☐ NO COMMENT				PROJECT:			
☐ COMMENTS AS MARKED. FABRICATION CAN PROCEED ACCORDINGLY. REVISED DOCT TO BE ISSUED EITHER FOR REVIEW OR AS FINAL CERTIFIED. HOWEVER ZAGROS WILL CHECK THIS REVISED DOCUMENT FOR PROPER INCORPORATION.				4th METHANOL PROJECT			
☐ REJECTED DOCUMENT TO BE REISSUED.				OWNER:			
☐ USE FOR INFORMATION ONLY.				CONTRACTOR:			
SIGNATURE				DATE			
ZAGROS REVIEW & COMMENTS DOES NOT ABSOLVE THE VENDOR OF THE RESPONSIBILITY FOR THE CORRECT DESIGN, MANUFACTURING AND OPERATION OF EQUIPMENT.				PIDEC PROJ. NO. 40404277			
Scale:				DWG. NO.			
Original Size:				PIDEC PROJ. NO. 1175			
Nominaton:				Rev.			
E-1007				10			
E-1008							
D-1003							
D-1004							
Basic document:				engineering			
DCC				Lurgi			
DG							
RT							
DL-NO.							
Job name:				REFORMING			
MEGA METHANOL IRAN				REFORMED GAS COOLING			
16966601				UNIT 100			
37117				P&I DIAGRAM SHEET 113			
Lurgi Job No:				Lurgi Document No:

**REFORMING
REFORMED GAS COOLING
UNIT 100
P&I DIAGRAM SHEET 113**

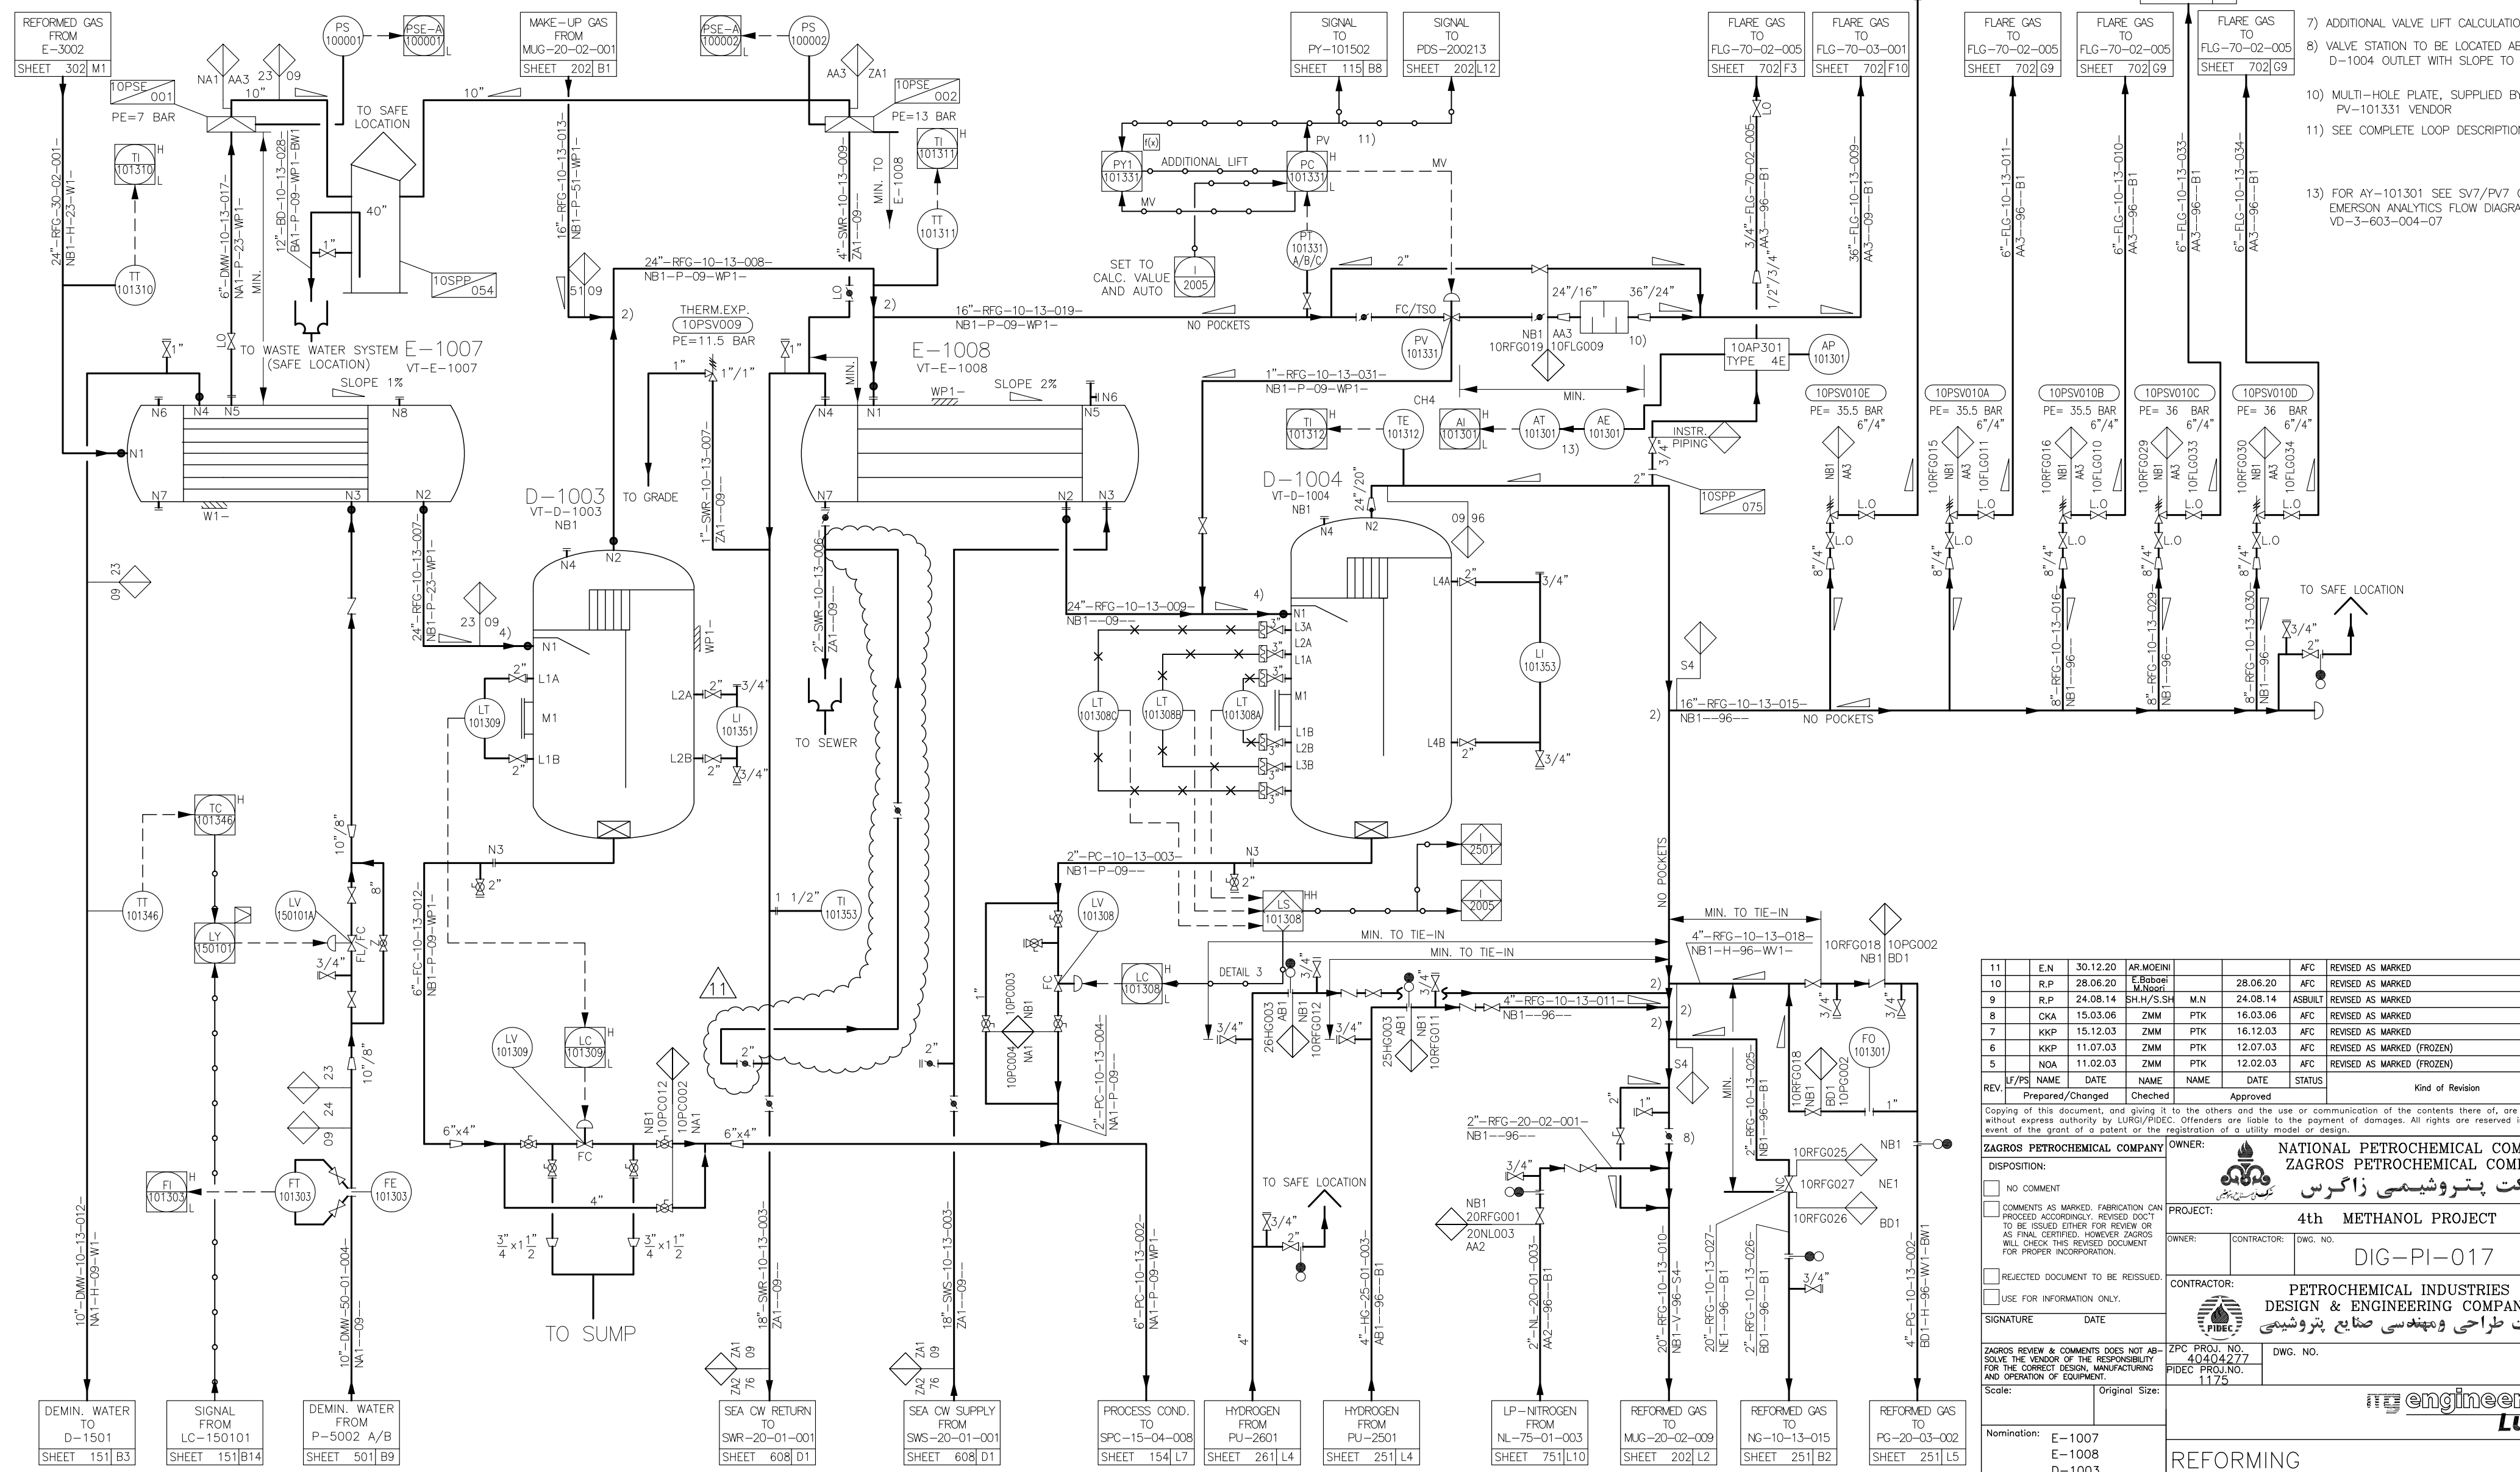
11	E.N	30.12.20	AR.MOEINI			AFC	REVISED AS MARKED
10	R.P	28.06.20	E.Babaei		28.06.20	AFC	REVISED AS MARKED
9	R.P	24.08.14	SH.H/S/SH	M.N	24.08.14	ASBUILT	REVISED AS MARKED
8	CKA	15.03.06	ZMM	PTK	16.03.06	AFC	REVISED AS MARKED
7	KKP	15.12.03	ZMM	PTK	16.12.03	AFC	REVISED AS MARKED
6	KKP	11.07.03	ZMM	PTK	12.07.03	AFC	REVISED AS MARKED (FROZEN)
5	NOA	11.02.03	ZMM	PTK	12.02.03	AFC	REVISED AS MARKED (FROZEN)
LF/PS		NAME	DATE	NAME	DATE	STATUS	Kind of Revision
REV.		Prepared/Changed		Checked		Approved	
Copying of this document, and giving it to the others and the use or communication of the contents there of, are forbidden without express authority by LURGI/PIDEC. Offenders are liable to the payment of damages. All rights are reserved in the event of the grant of a patent or the registration of a utility model or design.							
ZAGROS PETROCHEMICAL COMPANY				OWNER:			
DISPOSITION:				 شرکت پتروشیمی زاگرس
